Strata Energy, Inc., Ross In-Situ Uranium Recovery Project, Crook County, Wyoming; Notice of Materials License Application, Opportunity to Request a Hearing and to Petition for Leave to Intervene, and Commission Order Imposing Procedures for Access to Sensitive Unclassified Non-Safeguards Information for Contention Preparation

Supplemental Environmental Impact Statement for the Ross In-Situ Uranium Recovery Project in Crook County, Wyoming

RE: NRDC Comments on *Draft Supplemental Environmental Impact Statement for the Ross ISR Project in Crook County, Wyoming*, Docket ID NRC-2011-0148.

26. Figure 1. Variation plot for uranium and radium-226 showing distinct radium-226 values for 19xx18, which are due to the capture of the Nubeth contamination plume.

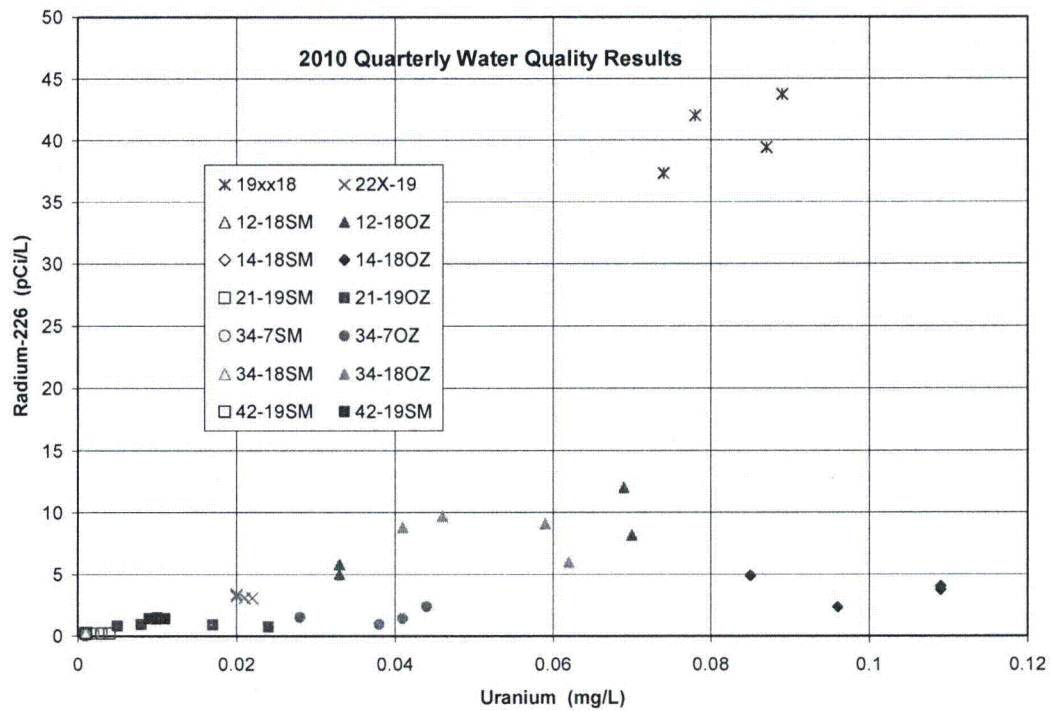
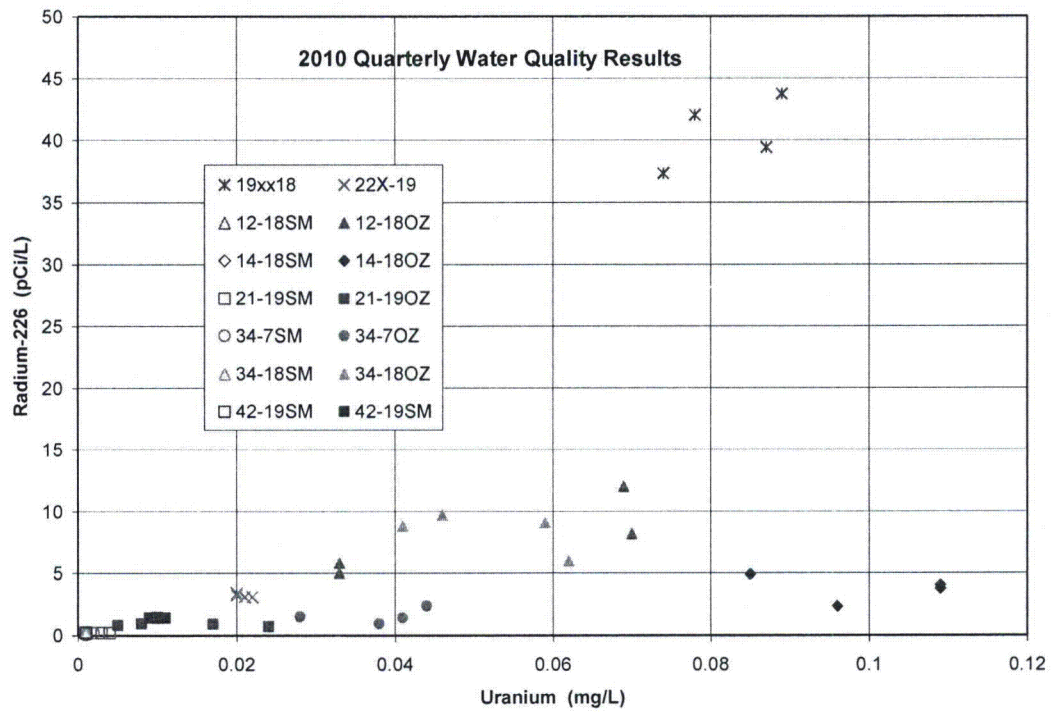
25. Failure to restore the groundwater under the Nubeth pilot-scale ISL operation is clearly evident in the consistently elevated uranium and radium-226 concentrations observed in samples from industrial well 19xx18 (Figure 1), which served as the extraction well to the Nubeth pilot-scale test (Figure 3.15 in the SEIS). The uranium-radium-226 trend observed for all Strata cluster wells from the OZ horizons and industrial well 22x19 lies well below the radium-226 values for 19xx18, and the high radium-226 values can only be explained by the capture of the contaminated plume that remains from Nubeth's failure to restore groundwater after their six-month pilot-scale test. In my expert opinion, failure to restore the groundwater after a short six-month pilot-scale project should have clearly communicated to the NRC staff that it will not be possible to restore a full-scale ISL operation in 8 months (DSEIS at 2-33).

35. Figure 2. Water-quality results for sodium and sulfate indicate groundwater mixing of the ore zone (OZ) and overlying horizon (SM).

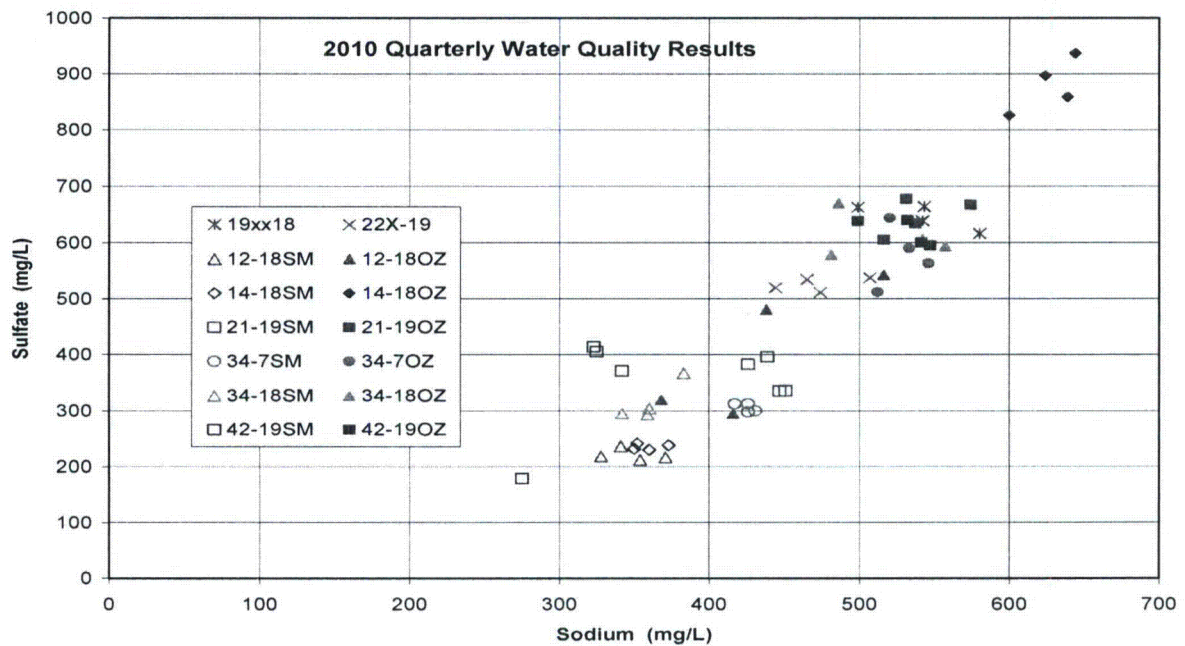
36. Figure 2 also illustrates that, the closer that a pair of samples plots for a given cluster well (e.g., 12-18SM and 12-18OZ), the higher the probability for groundwater contamination by communication between the two groundwater zones during ISL operations. In contrast to mixing between the 12-18 horizons, 14-18SM and 14-18OZ samples cluster tightly and are well separated on the plot. An explanation for the distinct separation of the 14-18 horizons on the sodium-sulfate plot may be that the density of exploration boreholes is lower around this cluster well and less communication between the SM and OZ horizons has occurred (*i.e.*, 14-18 may provide a snapshot of the distinct chemistry of the horizons prior to the drilling of thousands of exploration boreholes).

**Figure 2.6 [from page 2-4 of SEIS]
Schedule for Potential Lance District Development**

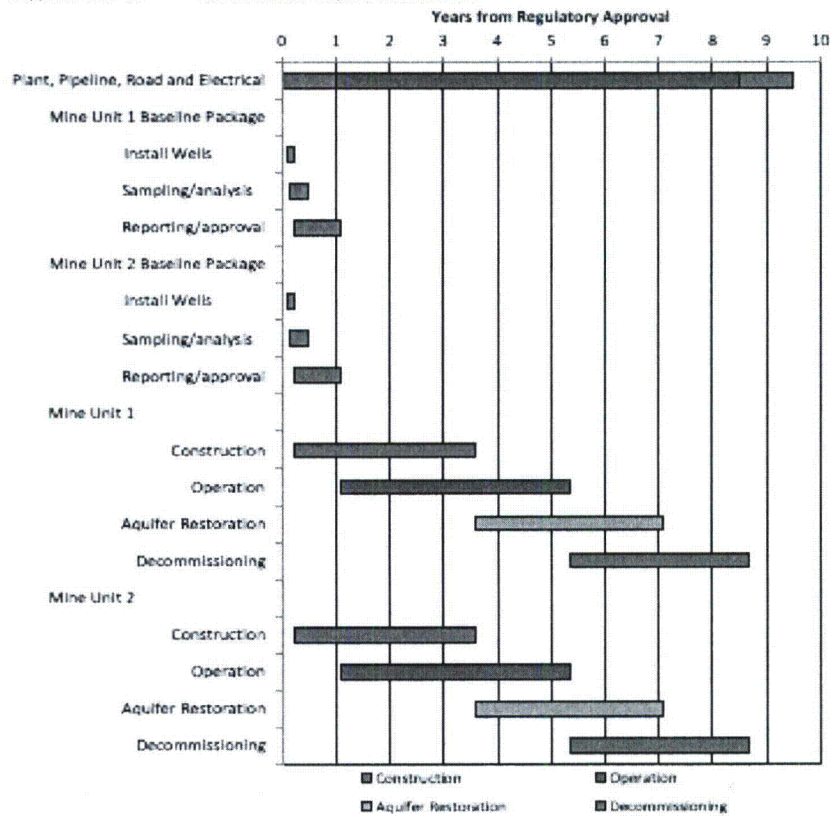
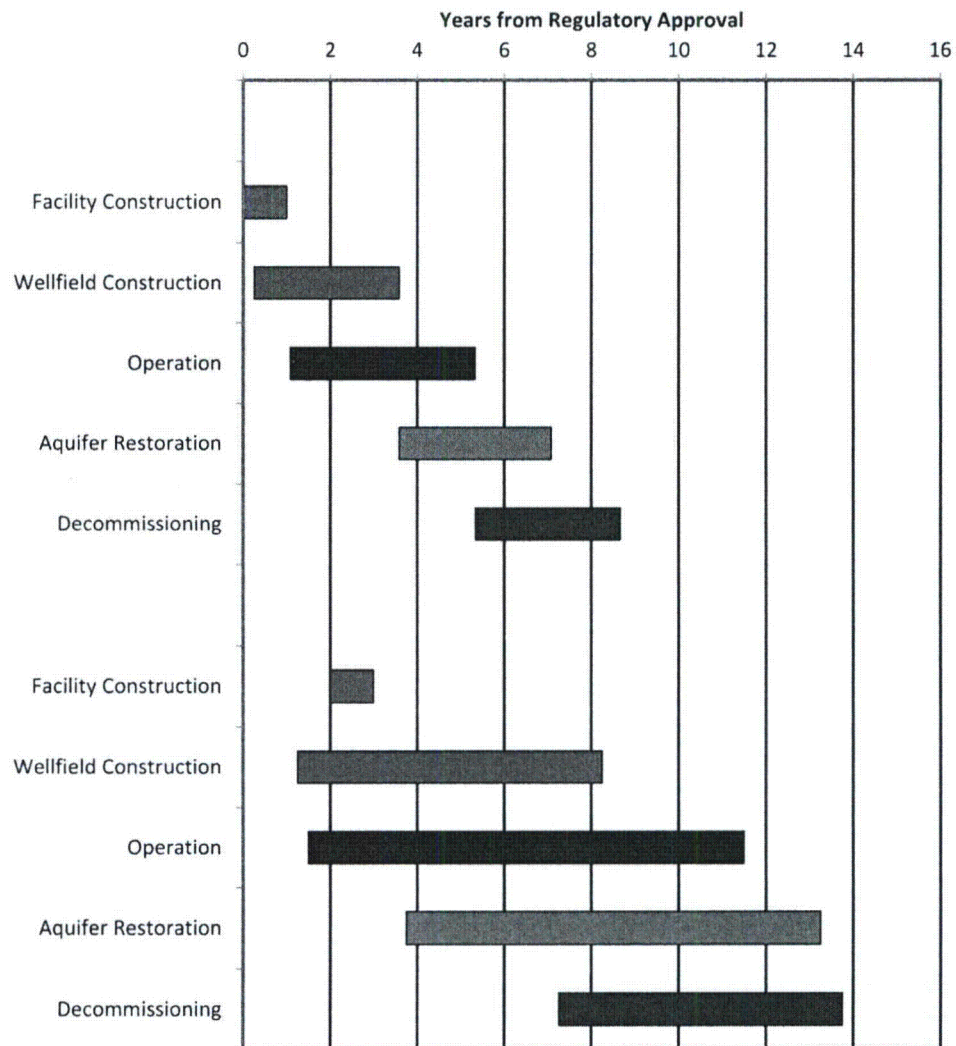
(a) The referenced Figure 2.6 contains no reference to a proposed “Ross Project,” but rather its title states that it describes a “Schedule for Potential Lance District Development.”

(2) Is the current title for Figure 2.6 in error, or is it the figure itself that is erroneous?

(b) Figure 2.6 shows an “aquifer-restoration only phase” being attained about 11.75 years after regulatory approval.

13. Below are two Figures, from the ER and DSEIS, respectively, that suggest a significant evolution has occurred in the Applicant's and the NRC's strategy and timing for uranium recovery operations in the Lance District beyond the Ross Project. The first figure below is cited in ER Section 1.3.2 on the "*Ross ISR Project Schedule*," and shows a 9.5 year project. This exact figure is not repeated in the SEIS, but one resembling it appears on SEIS page 2-8, but now carries the title, "Figure 2.6: Schedule for *Potential Lance District Development*," and conveys a timeline of 14 years, 4.5 years longer than the schedule described in the ER (see next page for figure).

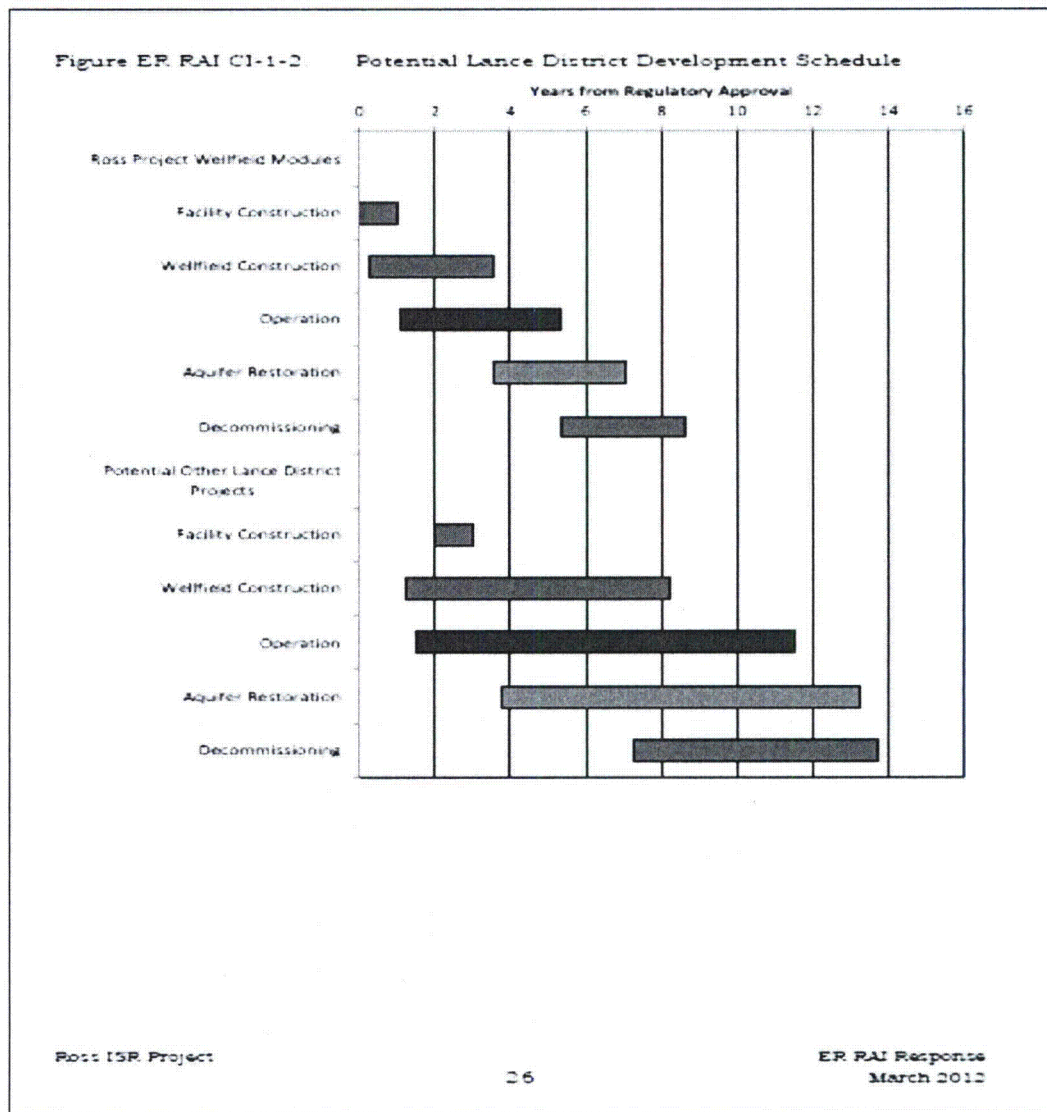
14. If one traces the above figure back to its source (“Strata, 2012a” RAI Response), one finds that the NRC Staff has deleted the subheadings “Ross Project Wellfield Modules” and “Potential Other Lance District Projects” that were present on the above chart in the RAI, subheadings that indicate that the Proposed Action *is really to license a single large ISR project via the Ross Project license and subsequent license conditions or amendments*

thereto, in which the various subsequent development “phases” clearly significantly overlap each other in time, and “satellite facility” construction *begins just a year after the first Ross Project well-field goes into operation*, and satellite well-field construction *begins less than a year after construction of the Ross Project well-fields*. Here is the March 2012 RAI Figure:

16. Note the NRC Staff's deletions (from the previous chart) of the headings "Ross Project Wellfield Modules" and "Potential Other Lance District Projects" from the above chart provided by Strata. Otherwise it is the same chart.

Figure ER RAI CI-1-1. Potential Future Lance District Projects

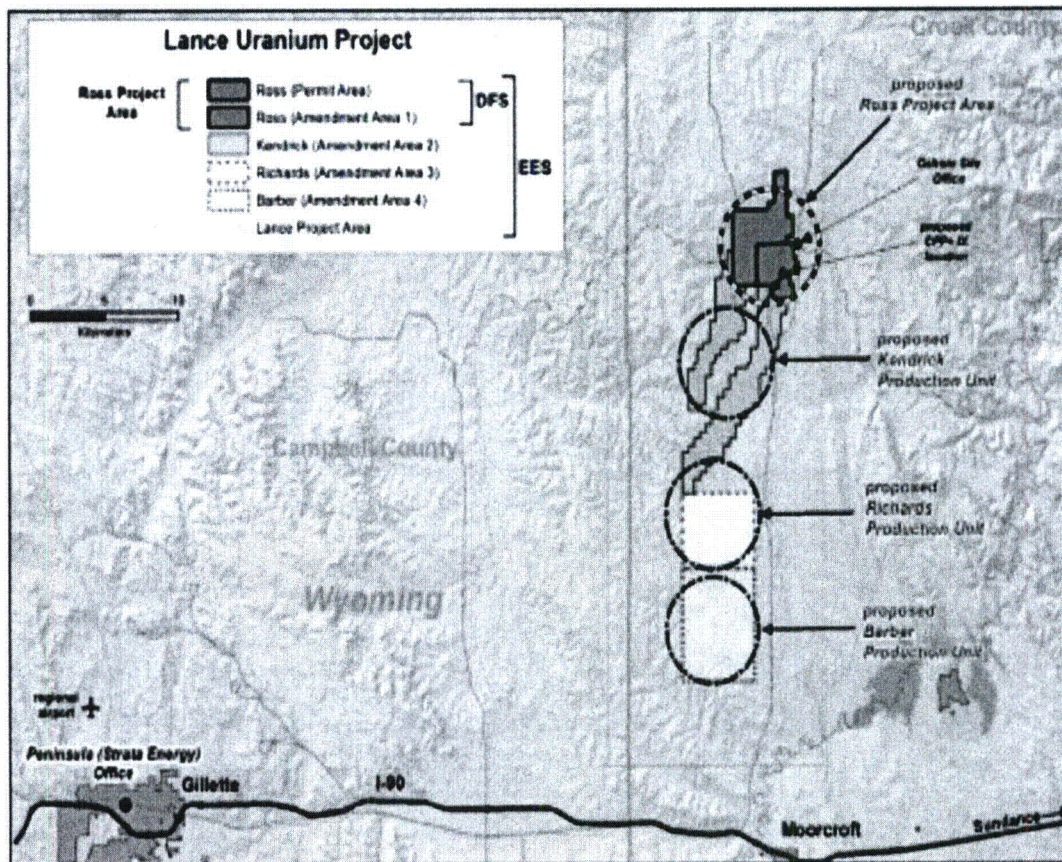
17. Below is Strata's plan, provided to NRC in the RAI of March 2012, and now reproduced on page 2-4 of the DSEIS, to march through the entire Lance District uranium roll-front deposit over the 14 years following regulatory approval. It reveals that the proposed "Ross Permit Area" subjected to analysis in the ER and DSEIS is but a small fraction of the total area to be mined. It was the NRC Staff's NEPA obligation, not Petitioners', upon receipt of this information to modify the scope of the Proposed Action in the DSEIS to fairly reflect the reality that this expanded sequence of planned "production units" would have much wider environmental impacts, over a more defined timeframe, than previously described in the ER.

20. Figure 1: Resource Area Location Map (Source: Peninsula Energy, January 23, 2013)

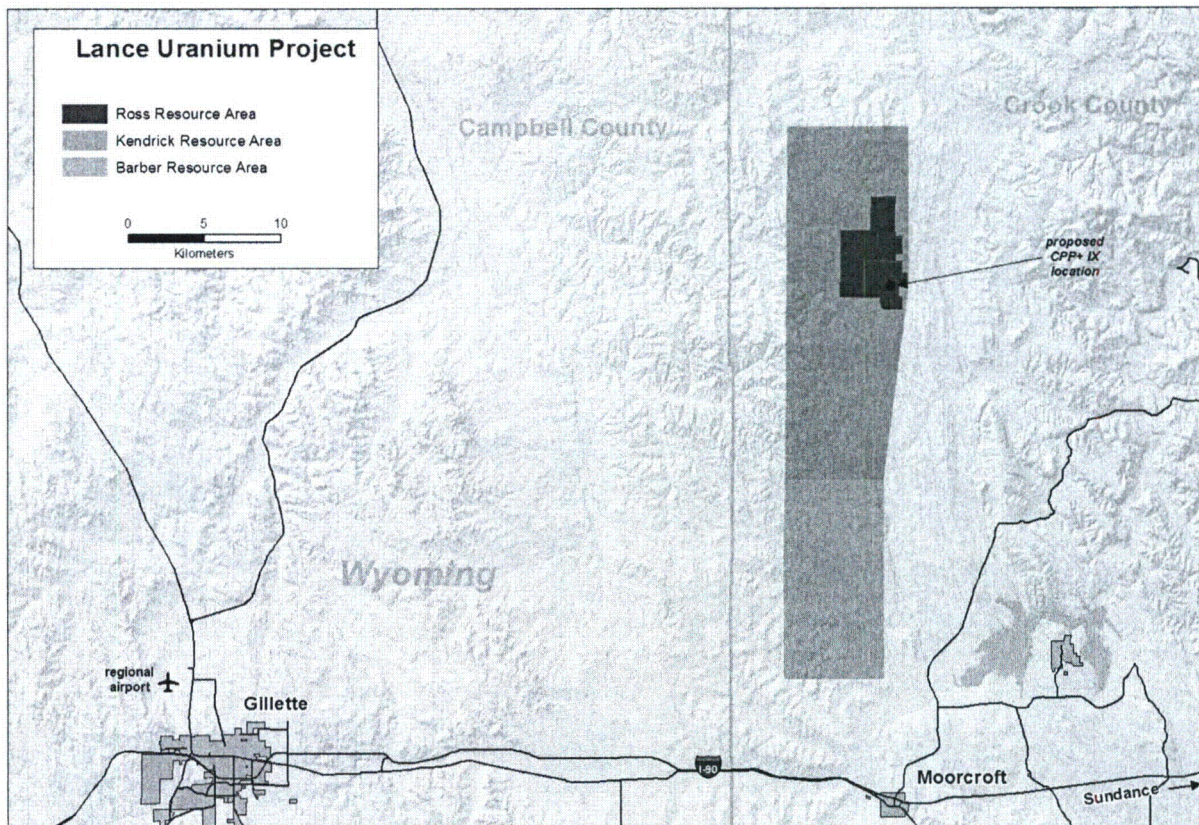
- 18.
19. Below is another map (dated 01/23/13) from the Australian corporate parent, Peninsula Energy, which differs from the previous maps in the ER, showing an expanded "Ross Resource Area" within an even larger "Kendrick Resource Area, which is in turn contiguous at its southern boundary with a "Barber Resource Area." This map is *prima facie* evidence that even the basic boundaries within which the environmental impacts of this proposed licensing action will be felt have not yet been defined, much less all the potential environmental impacts adequately considered as required under NEPA.

Lance – Exploration Potential

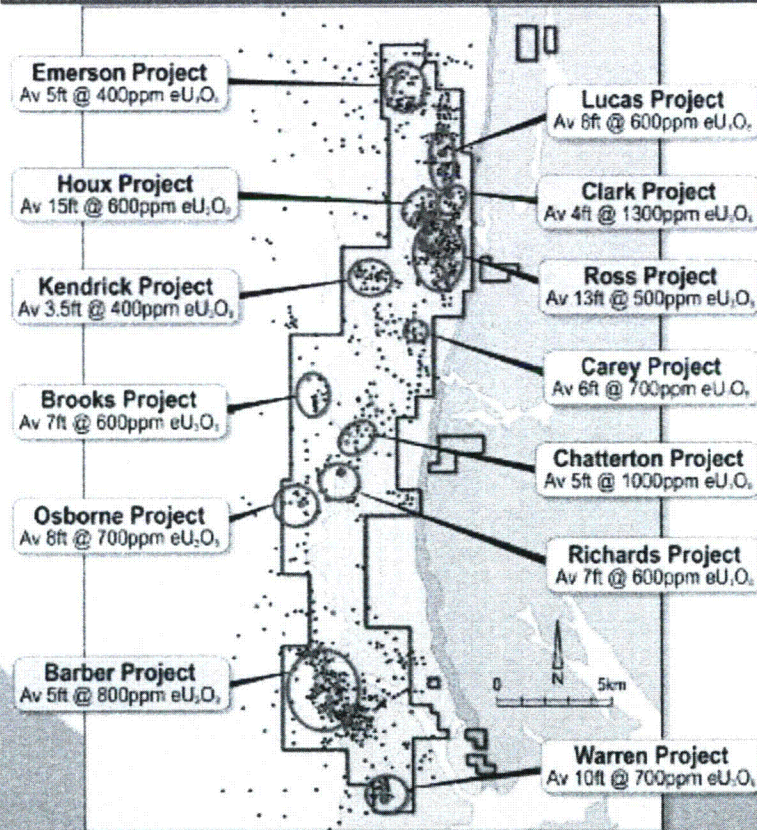
53. The graphic below from the Peninsula Energy Ltd. March 21 “2013 Company Presentation:
